Outgoing
5/027/0112

S0270112 Red Wheeler

2014 disturbance locations (Section 2).JPG
230K

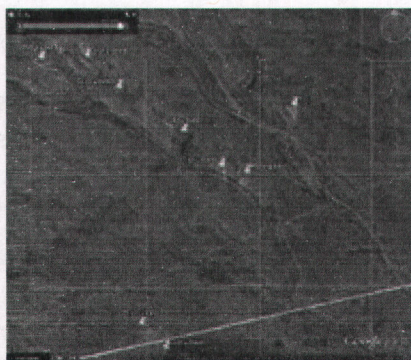
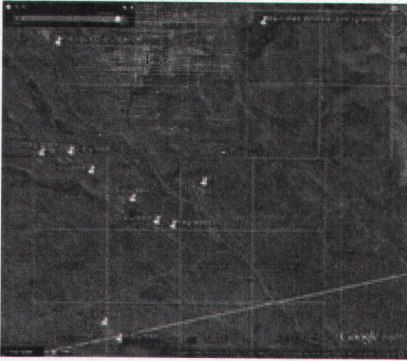
I visited the sites last week, and confirmed that the regrading of the biggest pit in Section 36 is finished, and it looks good. Vegetation is not fully established on any of the backfilled pits, and other sites identified in the approved Notice to the southeast in Section 2 are still open.

There are some unauthorized small pits and trenches in Section 2 that are not shown on the approved Notice maps and that help push the actual disturbance over the approved total disturbance of 1 acre (see attached Notice). Two of these pits were recently acceptably backfilled (last fall or earlier this spring). The total acreage not yet regraded is less than 1 acre, and the total disturbances (includes regraded areas waiting for revegetation) is about 2 acres.

So the bond is still adequate for the current disturbances (~ 1 acre). In order for the Division to approve future excavations, though, the Notice needs to be amended to update the total acreage to be disturbed and to show new and future disturbances on maps, and an archaeologist may need to survey future disturbances first. Also, acreage needs to be freed up by either backfilling some of the existing pits or by providing additional bond. The reclamation bond will need to be adjusted next year (April 2014), and it looks like the bond amount will probably go up by about \$2,000 for the next 3 year period. Bond amounts jumped up significantly in 2012 and 2013, so it looks like bonds will be higher than when this permit was first approved in 2011, fyi. Bond can be fully released in acre increments once regrading is complete (though some will need to be retained to cover revegetation).
